HISTORIC AND DESIGN REVIEW COMMISSION

HDRC CASE NO: 2023-106
ADDRESS: 501 E LOCUST
LEGAL DESCRIPTION: NCB 1736 BLK 10 LOT 1
ZONING: MF-33, H
CITY COUNCIL DIST.: 1
HIST. DIST. NAME: Tobin Hill Historic District
APPLICANT: Matthew Carson/Pella South Texas
OWNER: WOHLRABE SHANE & IRENE
TYPE OF WORK: Window replacement
APPLICATION RECEIVED: March 01, 2023
60-DAY REVIEW: Not applicable due to City Council Emergency Orders
CASE MANAGER: Jessica Anderson

The applicant requests a Certificate of Appropriateness for approval to replace 18 one-over-one wood windows with aluminum-clad wood windows.

Historic and Design Review Commission
Design Review Committee Report

Staff site visit
23 March 2023 9 AM

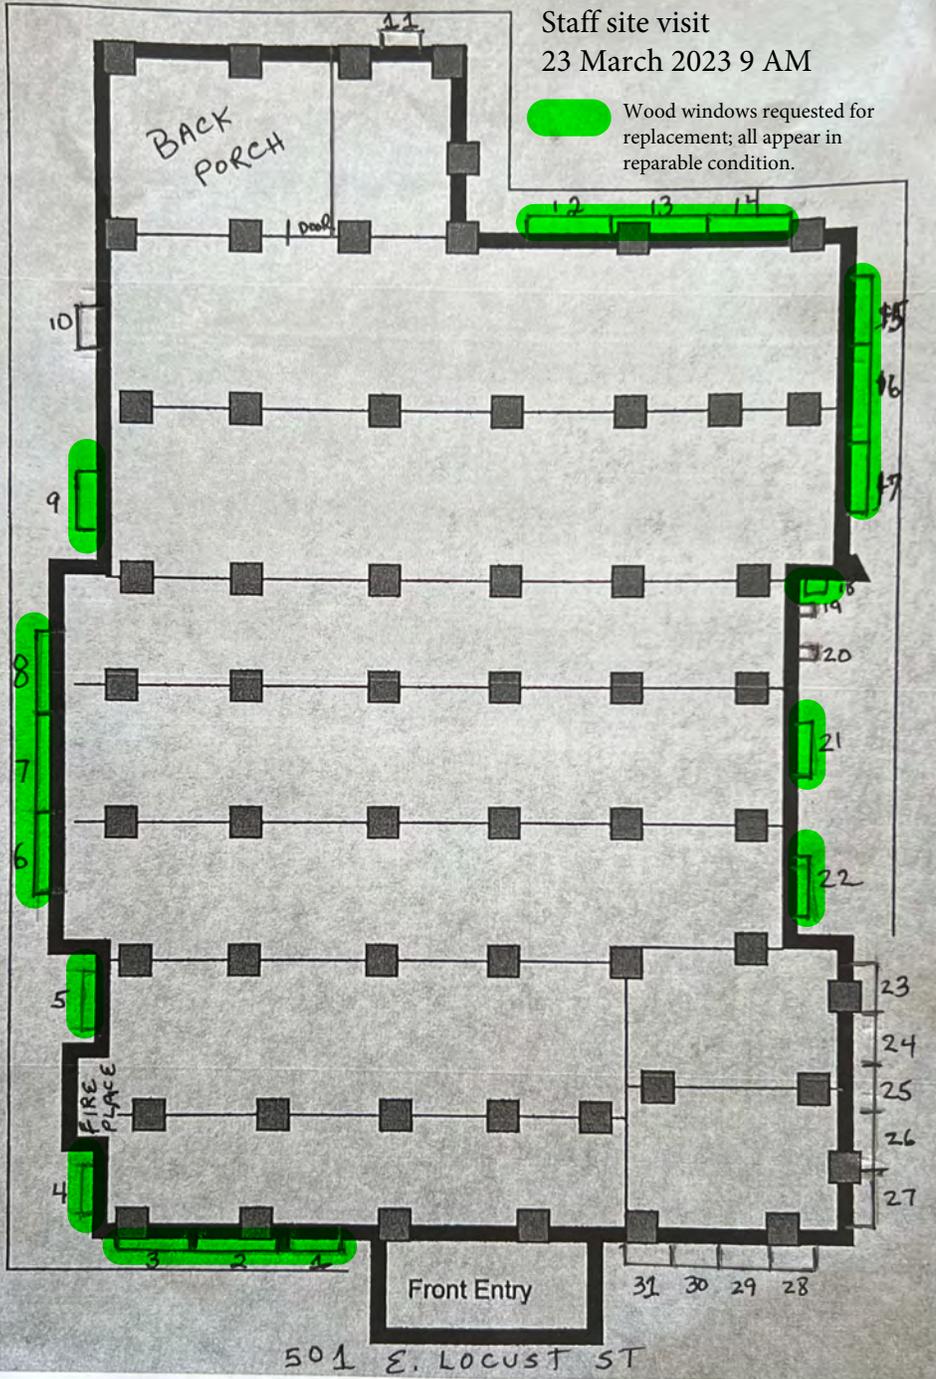
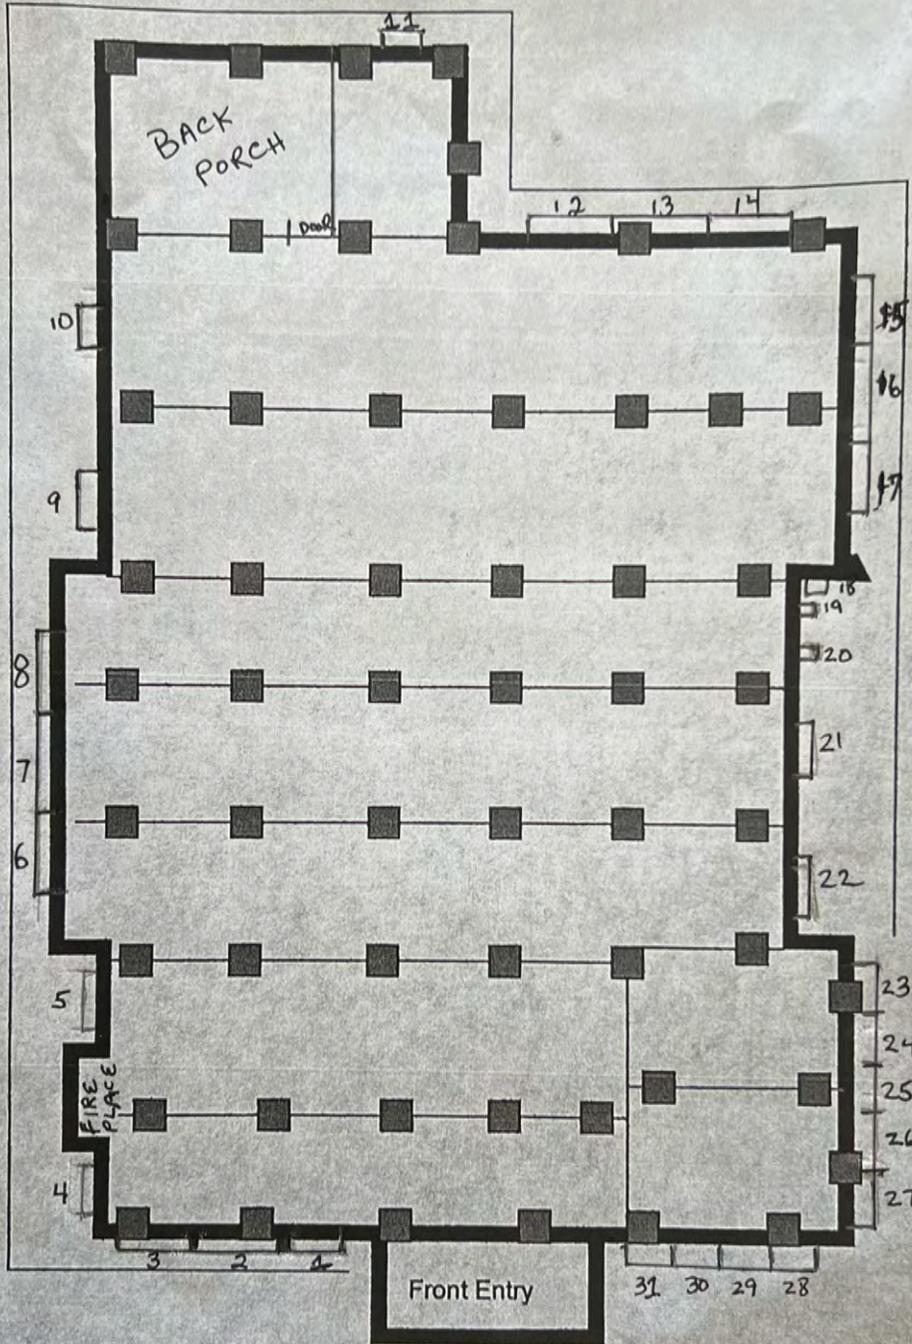
Wood windows requested for replacement; all appear in reparable condition.
